SPECIFICATIONS - Kitchen J05 + Butler's J04
RHK6581 Lee Smith

RHK6581 Lee Smith	**Scale: NTS**	**Sheet 1 of 7**
Kitchen J05 + Butler's J04	Do not scale off this drawing.	Drawn By:
38 Howard St, Grange QLD		Date: 26/10/26

Kitchen J05 + Butler's J04 Plan 1 : 20

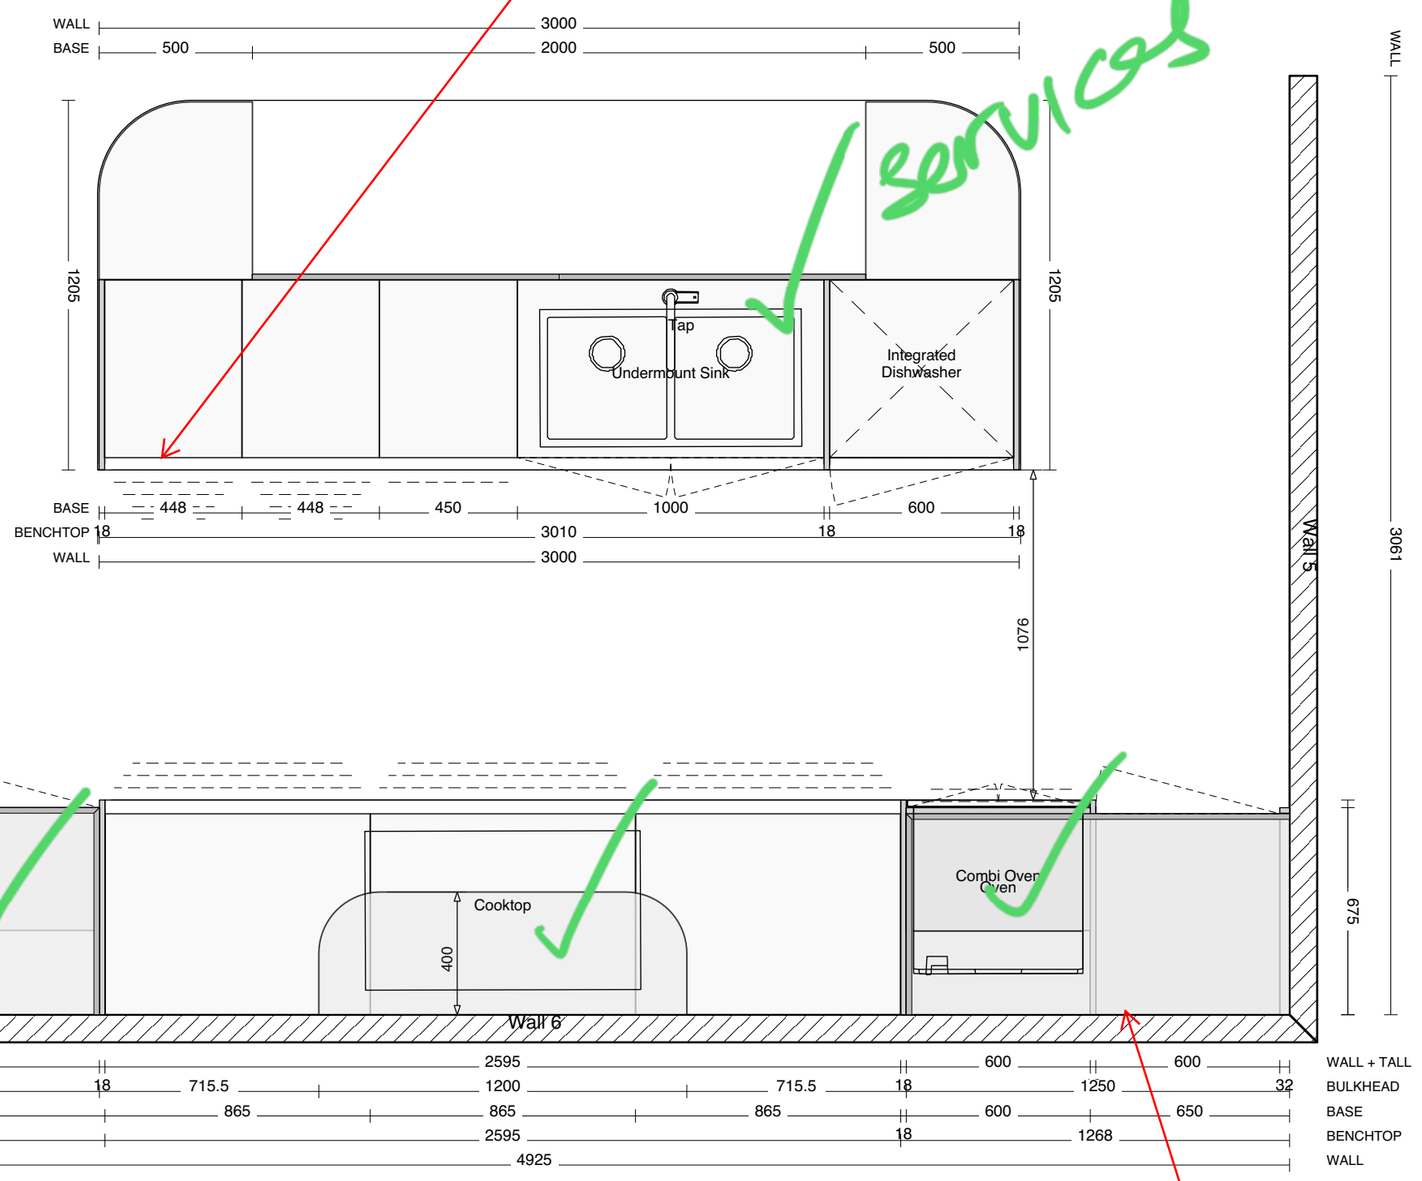
SHELVES TO FOLLOW CURVE.

NE CORNER = R500 CURVED WALL
BACK OF SHELF CPBD TRUNCATED
50 SCRIBE FILLER AT FRONT

TOP DRAWER OF THIS DRW STACK IS TO BE A CHARGING DRAW. ALLOW FOR 2 DGPO AT REAR OF DRAWER.

need to run power to island.

DGPO AT REAR OF CABINET

Kitchen J05 + Butler's J04 Elevation Wall 6 1 : 20

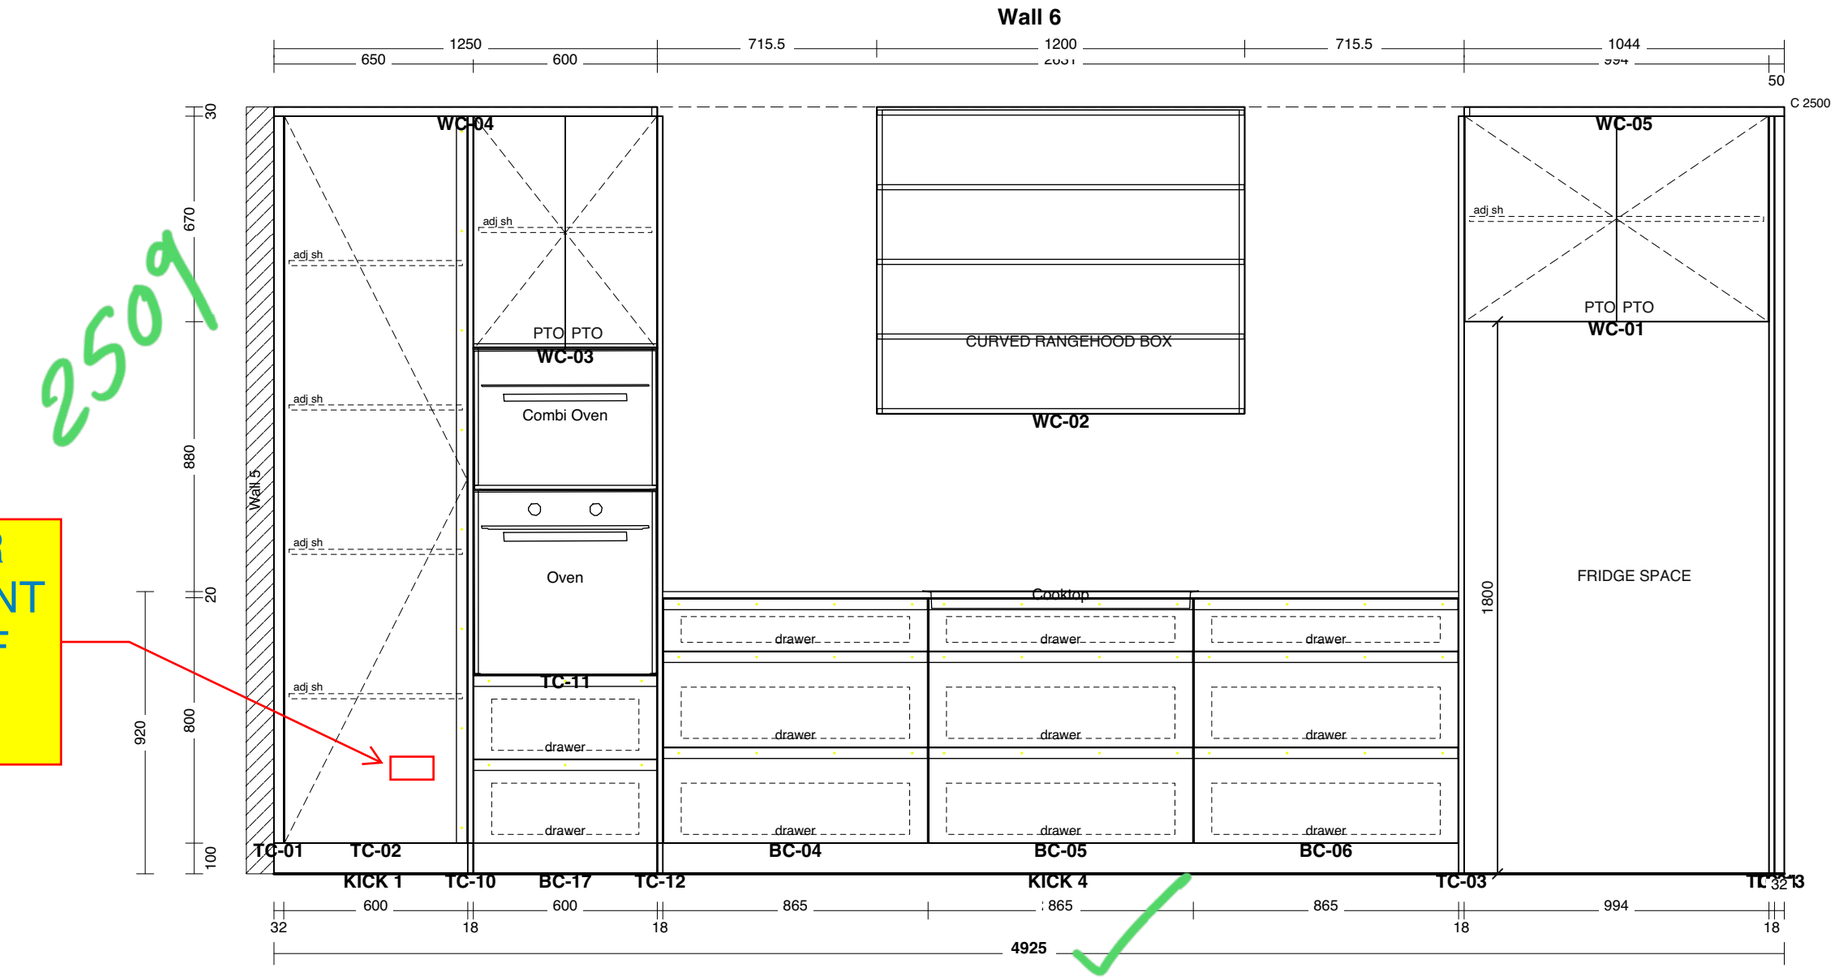
ALLOW FOR POWERPOINT AT REAR OF CABINET

Kitchen J05 + Butler's J04 Elevation Wall 7 1 : 20

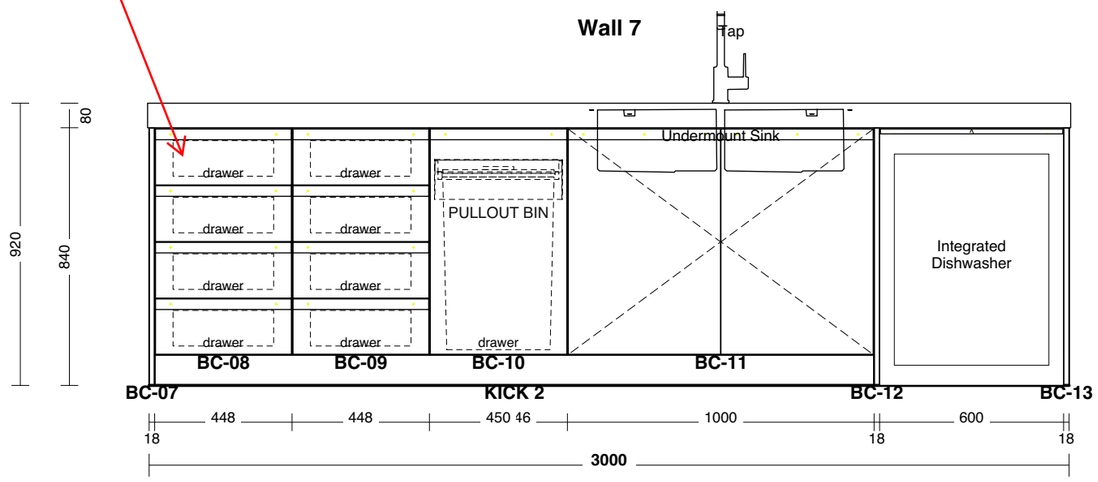
TOP DRAWER OF THIS DRW STACK IS TO BE A CHARGING DRAW. ALLOW FOR 2 DGPO AT REAR OF DRAWER.
